BID # 03-220616

ADA UPGRADES & PARKING LOT STRIPE & SEAL VICTOR ELEMENTARY SCHOOL DISTRICT VICTORVILLE, CA

June 13th, 2022

ADDENDUM - 02

A0.1

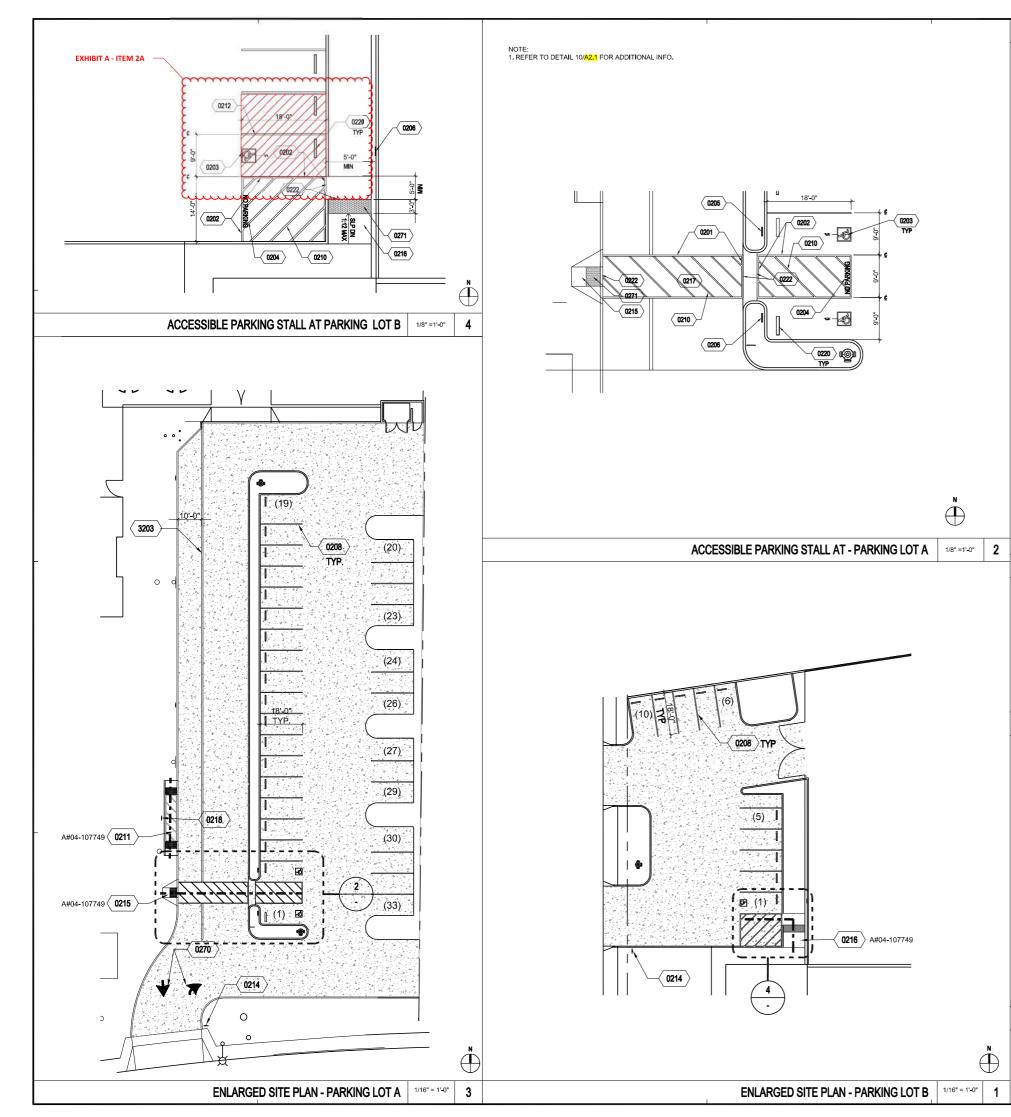
AREA OF WORK. PARKING LOT B. SEE 1/A1.1 DSA APP. # 107749

EXHIBIT A - ITEM #24

A0.1

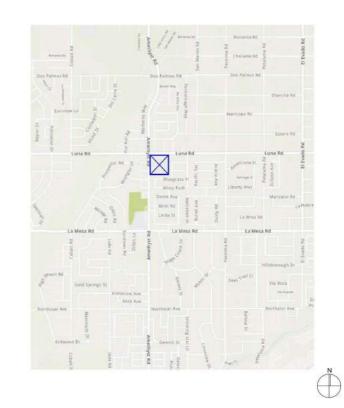
REMOVE & REPLACE 2400 SE

OF ASPHALT PER EXHIBIT A

ITEM 10A

REMOVE & REPLACE 400

EXHIBIT A ITEM 10A
